CHASE RETAIL BANKING CENTER

## **ROUCH ARCHITECTS CITY OF ALBUQUERQUE CHANGE TO PLANS NARRATIVE**

**JPMorgan Chase Bank Eubank Blvd NE and Chico Rd NE  
340 Eubank Blvd., Albuquerque, New Mexico 87123**

**CITY OF ALBUQUERQUE PERMIT #: BP-2020-36265**

01 SITE PLAN  
SCALE: 1"=10'-0"

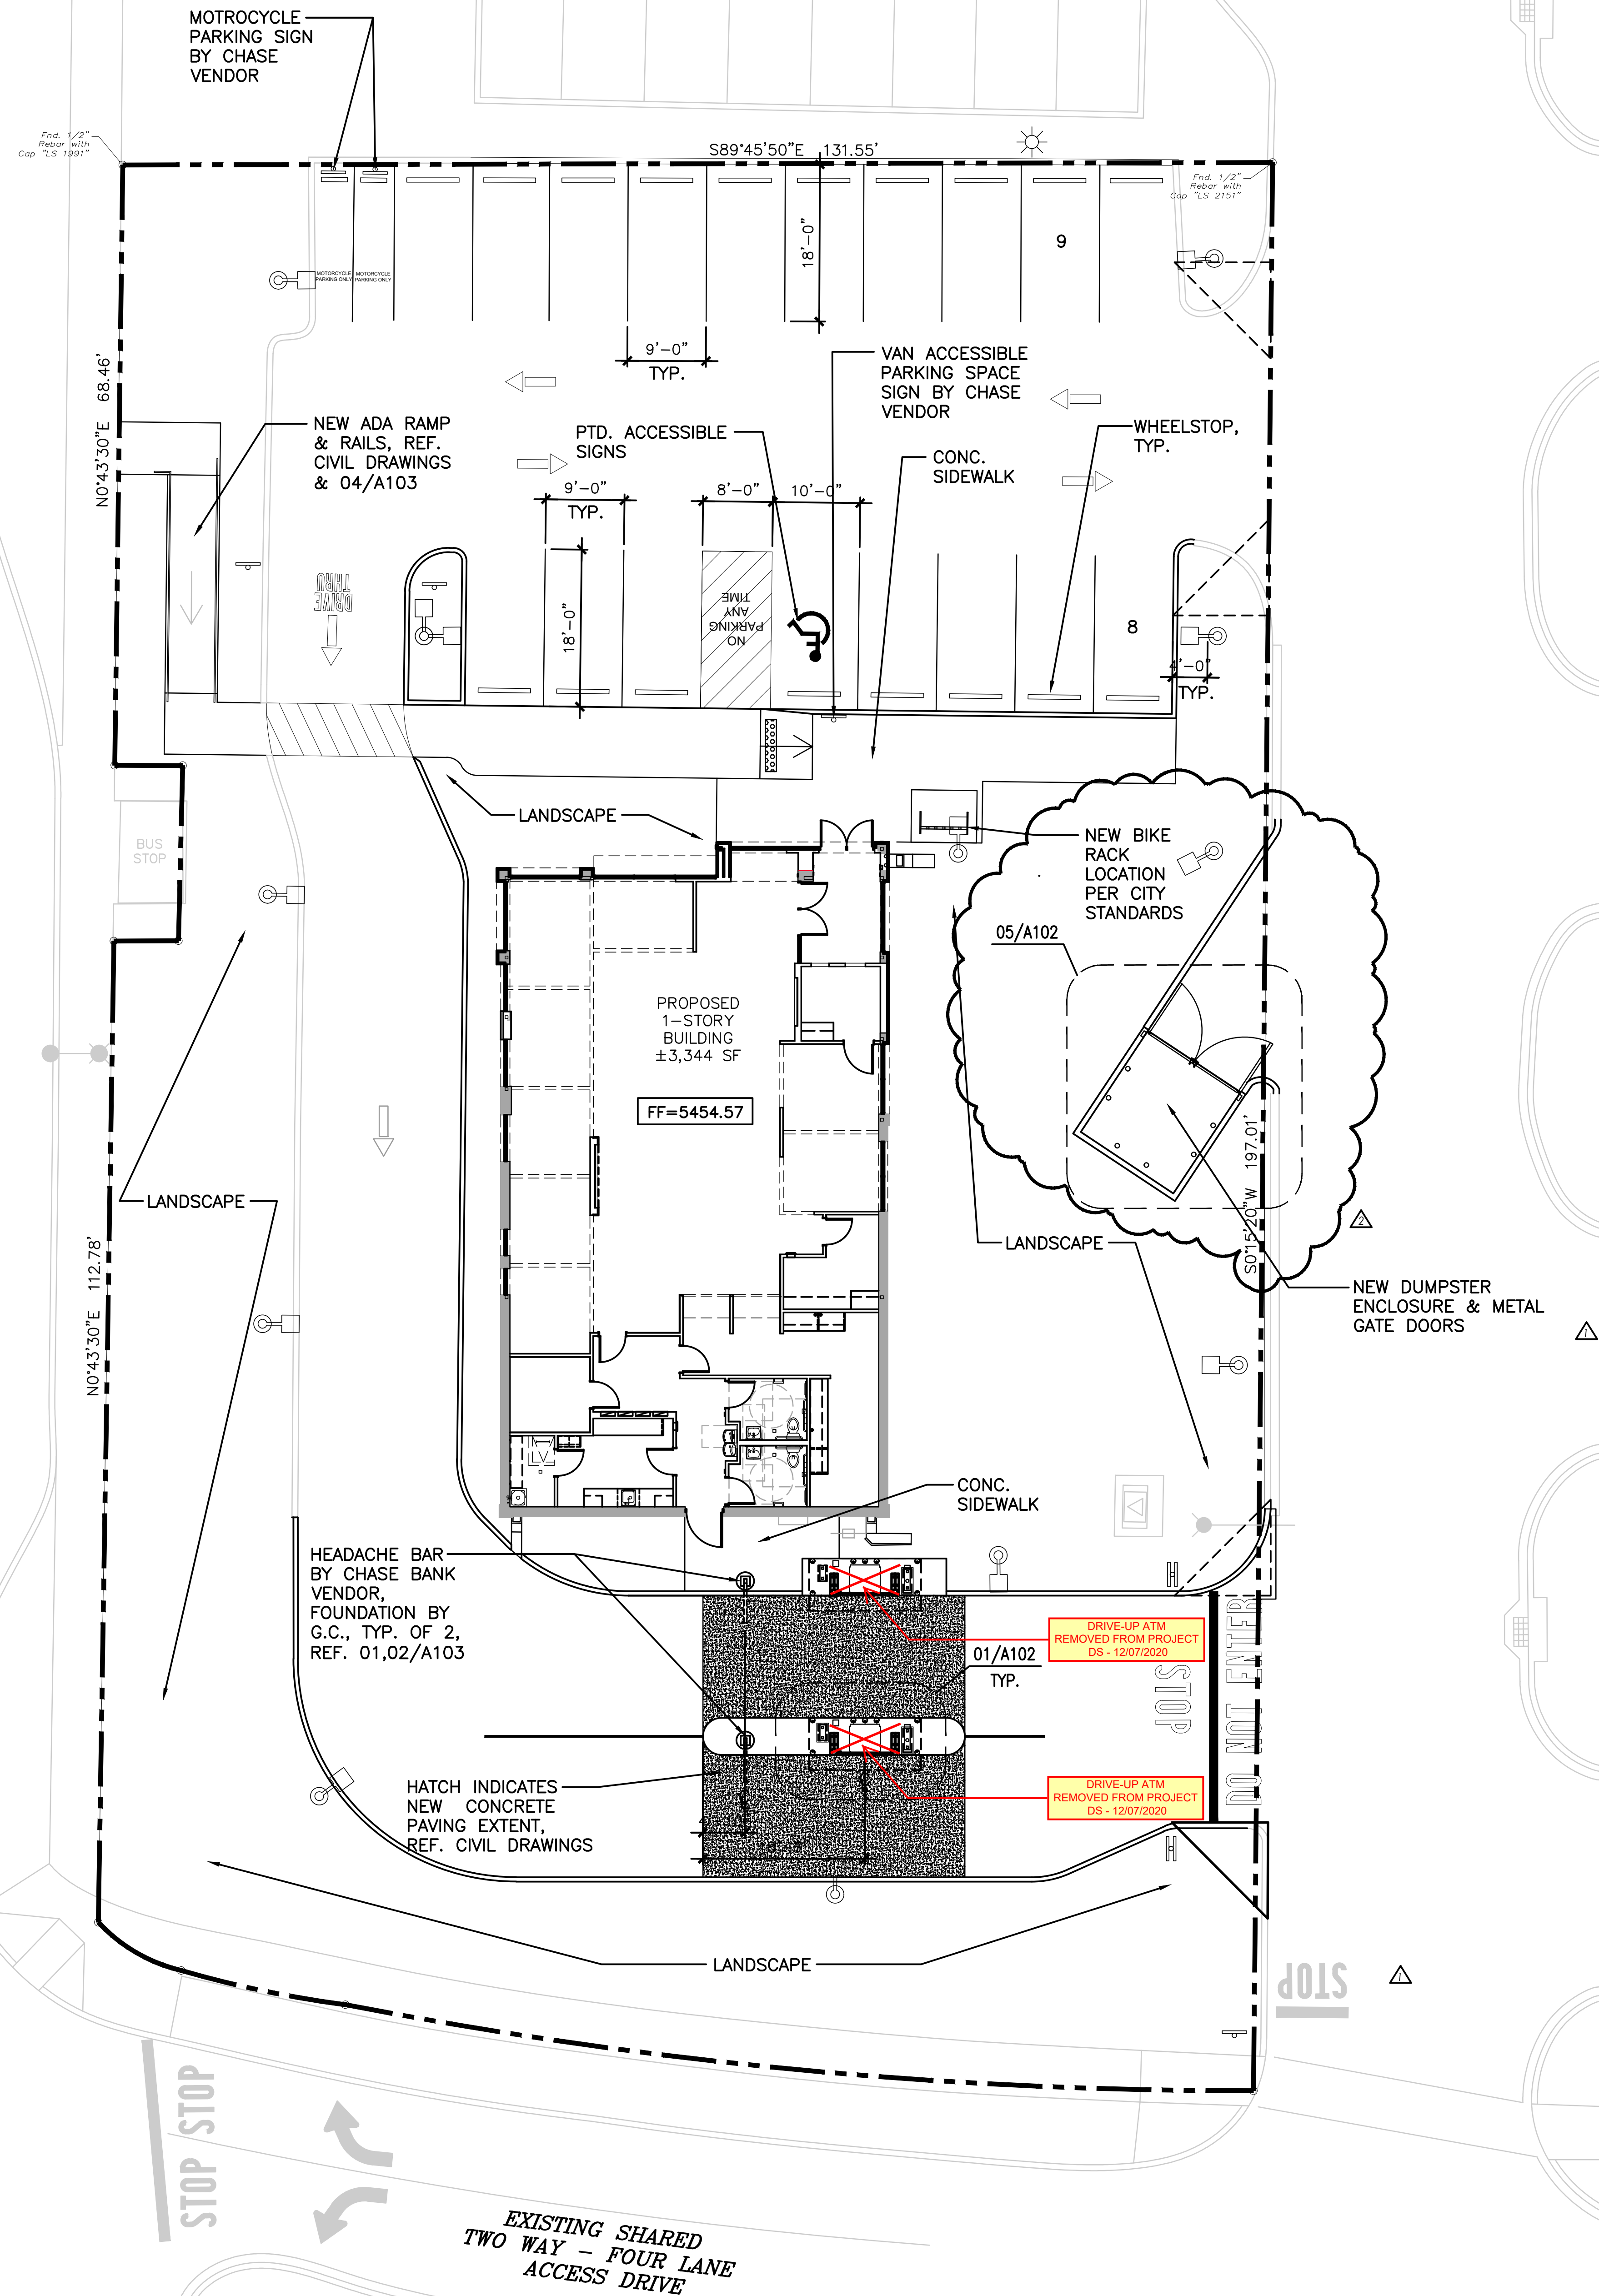
With this letter, the applicant would like to remove the two drive-up ATM's from this project.

Please reference revised drawings A101 Site Plan, MEP102 MEP Site Plan, E202 Photometric Plan, and TC102 Telecom Site Plan, indicating removal, uploaded to the "Drawings" folder.

#### SITE PLAN

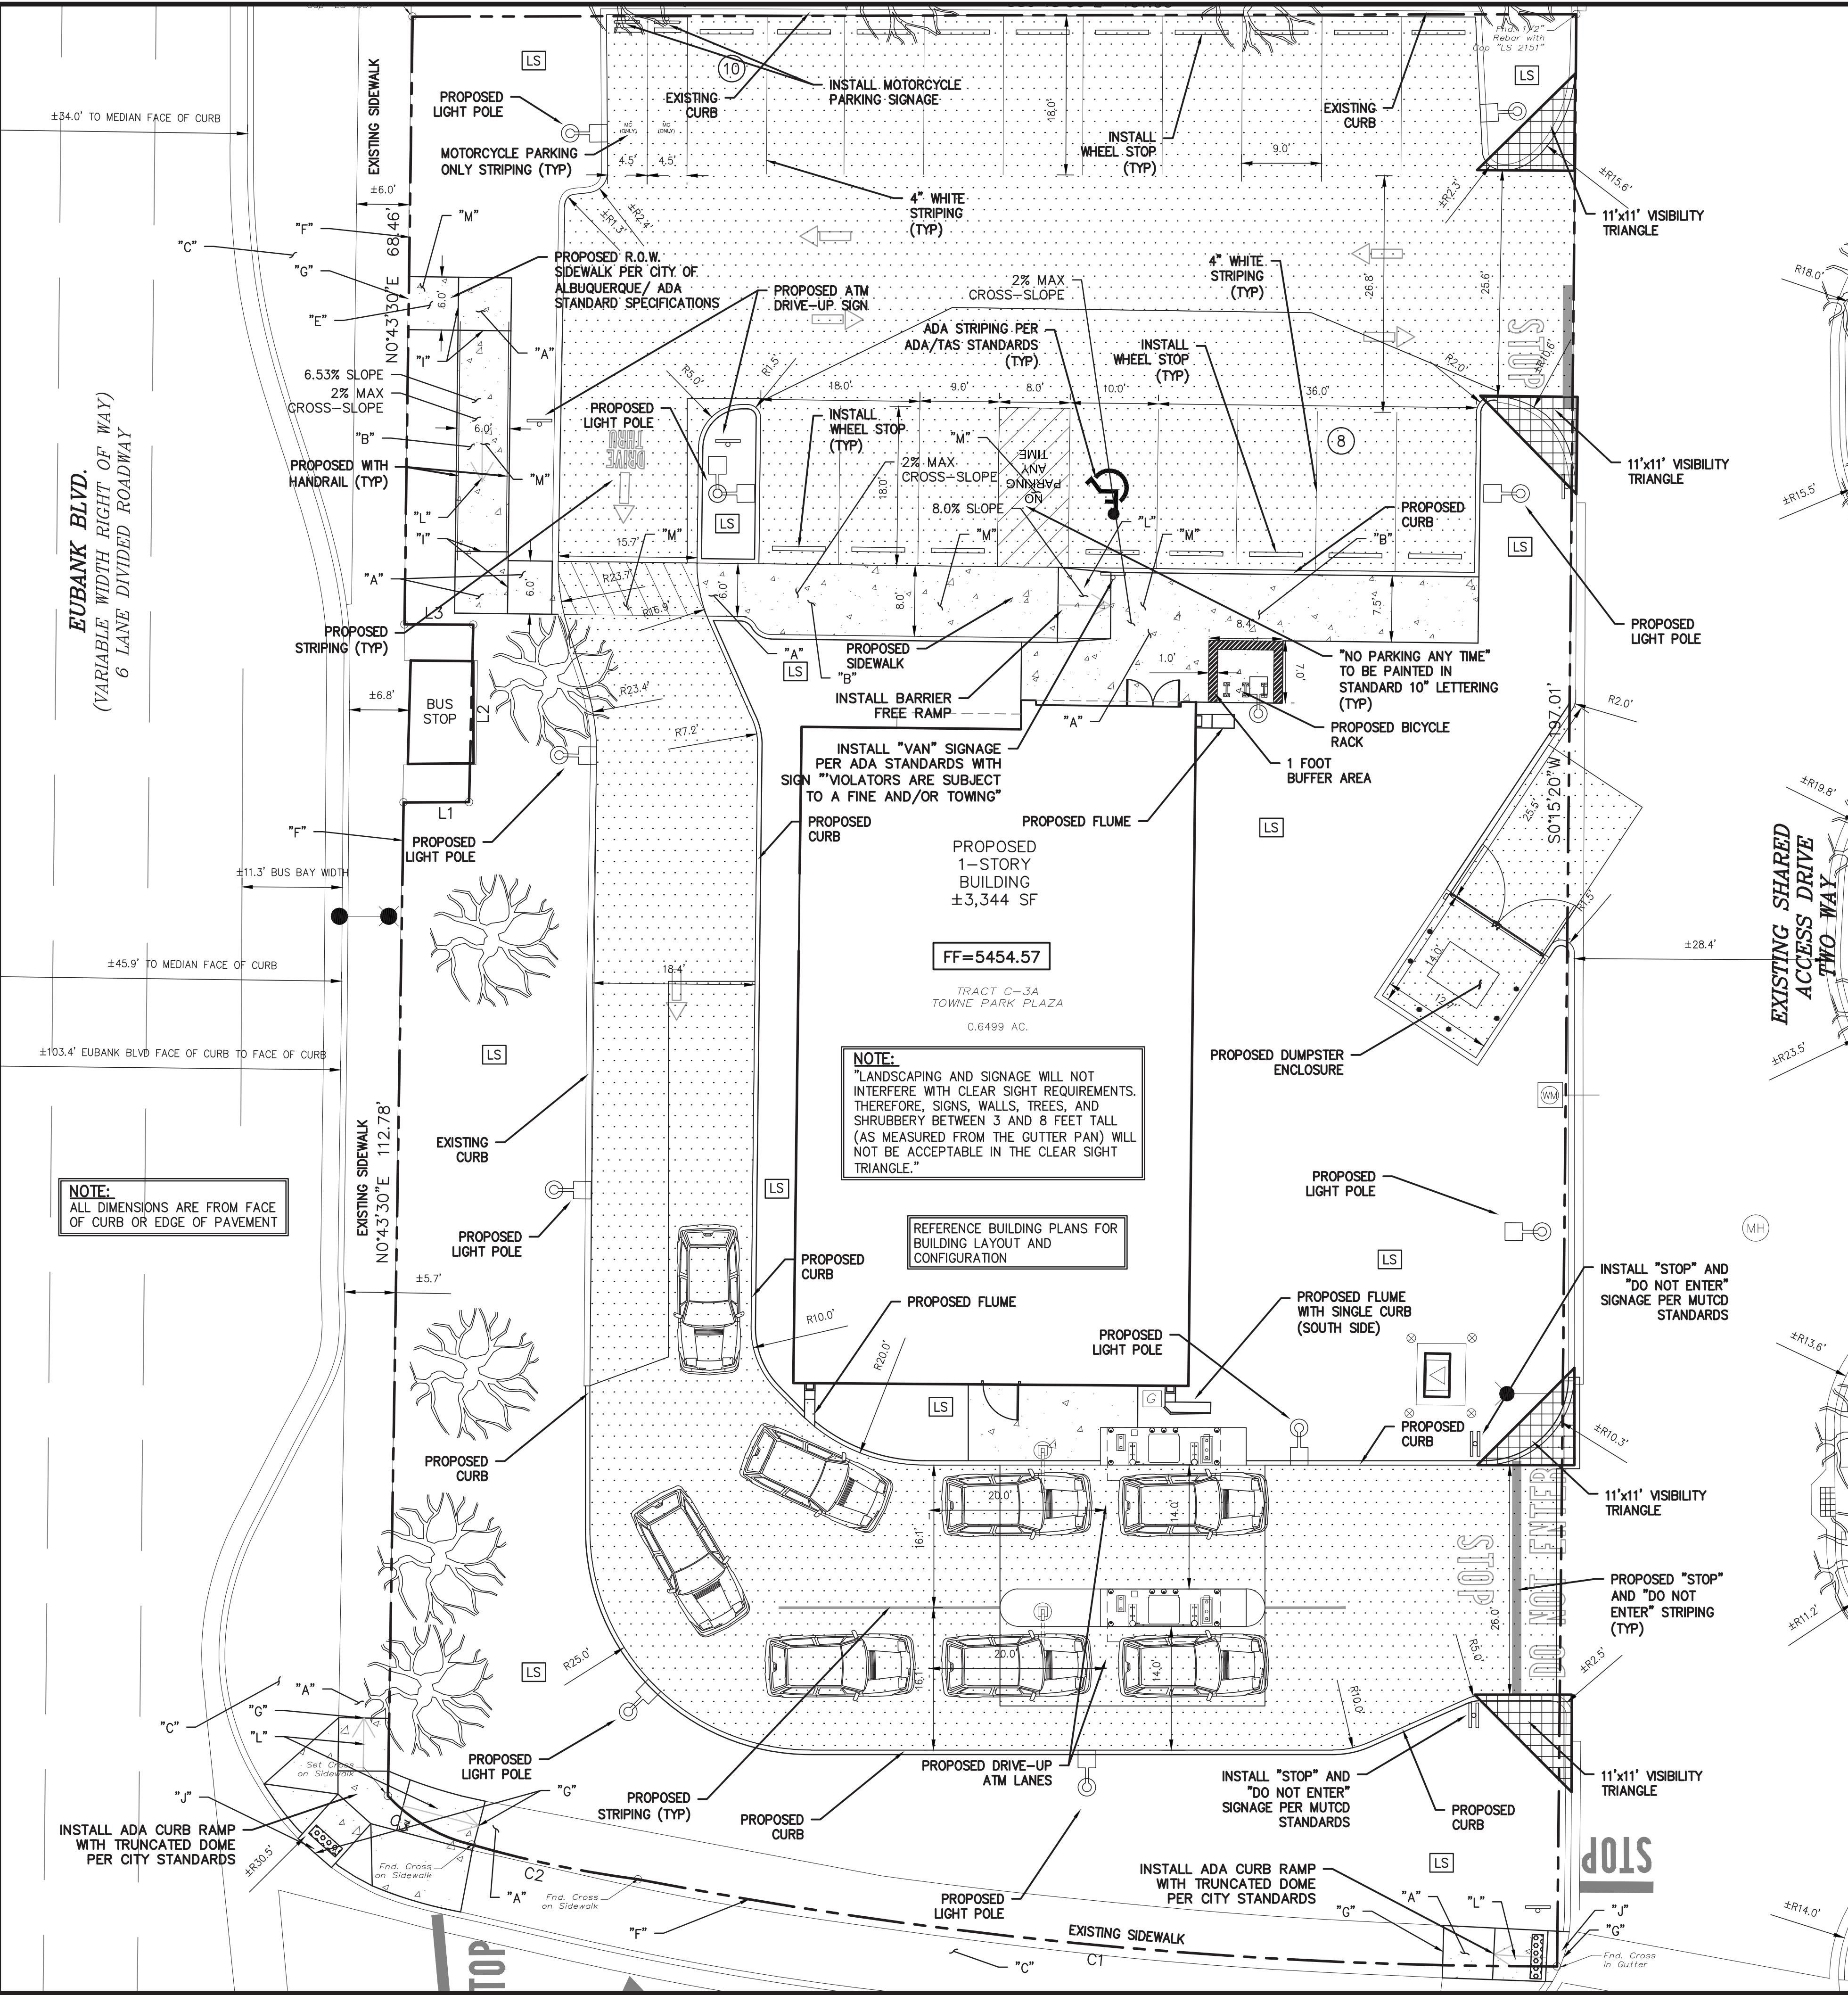
Thank you for your updates. The only comments I had left were on the curb and bike rack details. Our bike rack detail is specific per Albuquerque's ***"Integration Development Ordinance"*** (See

Also, the curb detail you have shown is not the same as our requirements based on the flowline being in the middle of the curb shown on your detail. (You have called out 2415 on the site plan, but I was not sure which detail you are referring to. For Transportation, we just want to make sure it is 6" -8" high, basically.) You may call out a specific detail on 2415 or provide a separate detail. I just thought that the note on the site plan and the detail sheet under "Drainage" were conflicting.

1. All bicycle racks shall be designed according to the following guidelines:
  - a. The rack shall be a minimum 30 inches tall and 18 inches wide.
  - b. The bicycle frame shall be supported horizontally at two or more places. Comb/toaster racks are not allowed.
  - c. The rack shall be designed to support the bicycle in an upright position. See the IDO for additional information.
  - d. The rack allows varying bicycle frame sizes and styles to be attached.
  - e. The user is not required to lift the bicycle onto the bicycle rack.
  - f. Each bicycle parking space is accessible without moving another bicycle.
2. Bicycle racks shall be sturdy and anchored to a concrete pad.

We replaced the bicycle rack and updated the curb to reflect dwg 2415.
